Chill compartment compensation.

Review Eco-design and Energy Label Cold Appliances

On behalf of CECED,

15410 / CE45 / V1

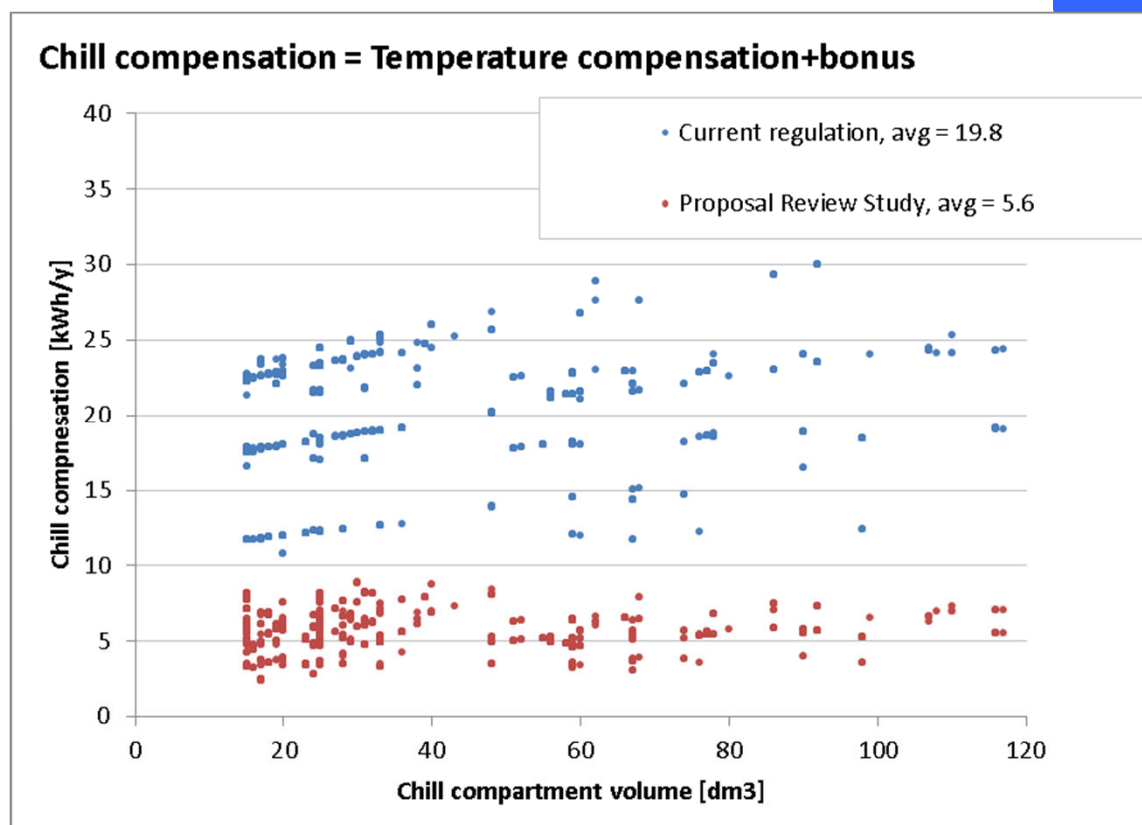
- For chill compartment, N_c and M_c of fresh food are applied
- No compensation provided so far on the basis that:
 - No plausible explanation has been provided; See note 15116/CE12/V5
 - Average ambient temperature < 25; holds for all compartments
- Target temperature chill changes from 0 to 2 °C in the new global standard
- Temperature compensation r_c reduces from 1.25 to 1.1
- Combined effect:

Motivation *CH* compensation

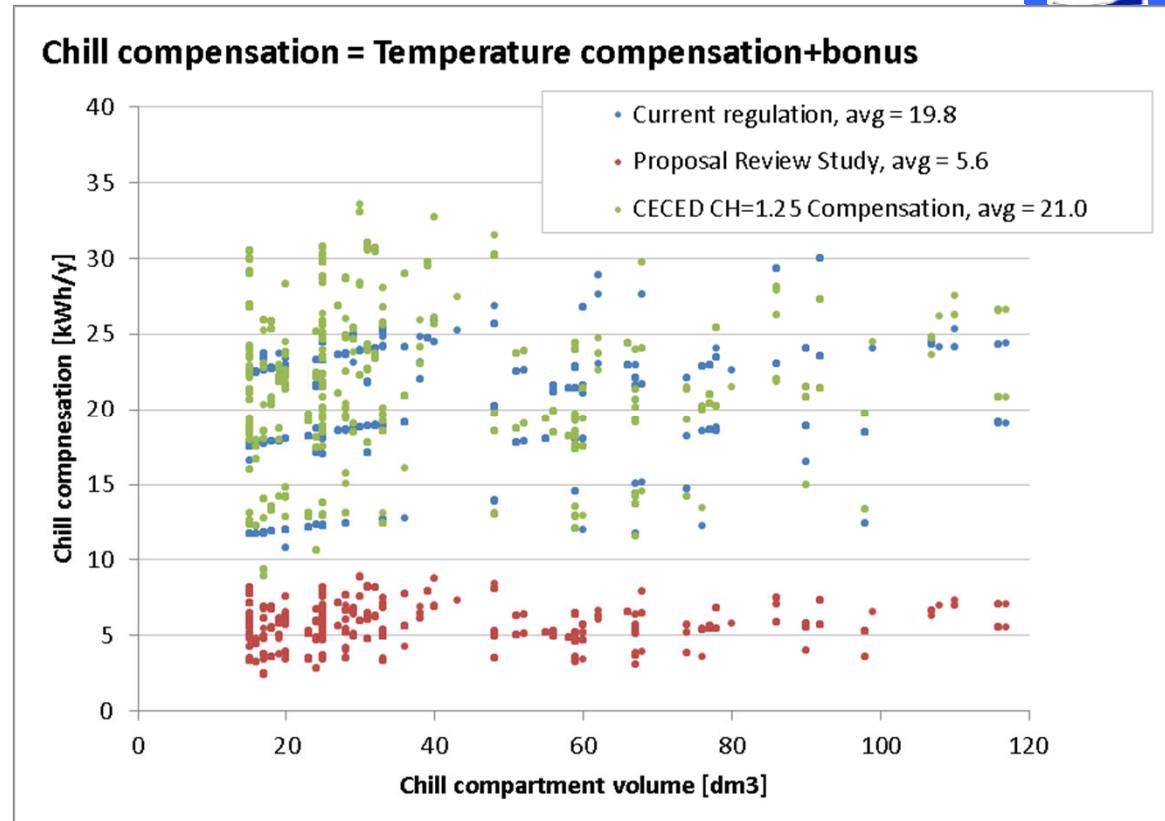
- Technical justification
 - Stringent temperature requirement (all temperatures between -2 and +3 °C, independent of thermostat setting and ambient temperature)
 - Need of additional fan (requiring extra energy and volume)
 - Requires air ducting which reduces volume
 - Requires electronic control resulting in increased consumption during compressor-off
- Difficult to compare the same product with and without chill
 - Products have been designed for chill
 - Additional measures taken due to limited compensation today (e.g. local increased insulation).

- In proposed metrics for q-ref, simplest approach is to add a compensation: $q_{ref} = D \sum_{c=1}^n A_c B_c C_c CH_c \left(\frac{N_c}{V_c} + r_c M_c \right)$
 - For chill compartments > 15 liter
 - Propose $CH_c=1.25$
- Average effect same as current
- Alternative: use M and N coefficient of frozen food
